OPTIONAL SERVICE BULLETIN

Number: **03**
Revision: **NEW**

1.1.1 This Service Bulletin (SB) applies to PWI's STC# SA01748WI, part number 6910080-000.

1.4.1 This SB describes a procedure change the installation of the provided resistor.

Current wire connections

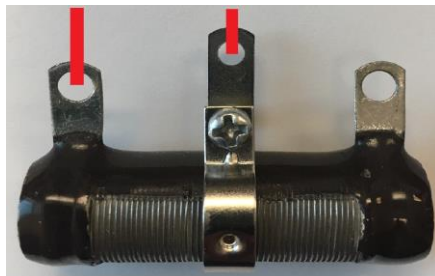
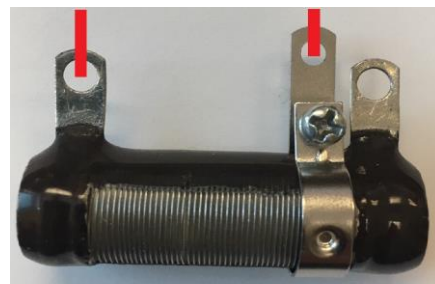
This service bulletin action will insure the resistor is set to its maximum resistance.

- 3.1.1 Turn off all breakers to power for main cabin.
- 3.1.2 Remove lamp cover plate by pulling gently on all sides.
- 3.1.3 Remove lamp 350-3380V003-001. You need not disconnect connector.
- 3.1.4 Add 1 each 1" x 3/8" piece of tape over the top of the already attached tape covering the location directly on top of the solder connections of the connector harness to the pc board.
- 3.1.5 Loosen screw on WW resistor and slide it as far as it can go away from other lead wire and retighten screw.

New wire connections

- 3.1.6 Reattach lamp to cover plate.
- 3.1.7 Replace the cover plate back to its original location insuring all posts are securely in the rubber grommets.
- 3.1.8 After modification is made, switch breaker for cabin power back on.
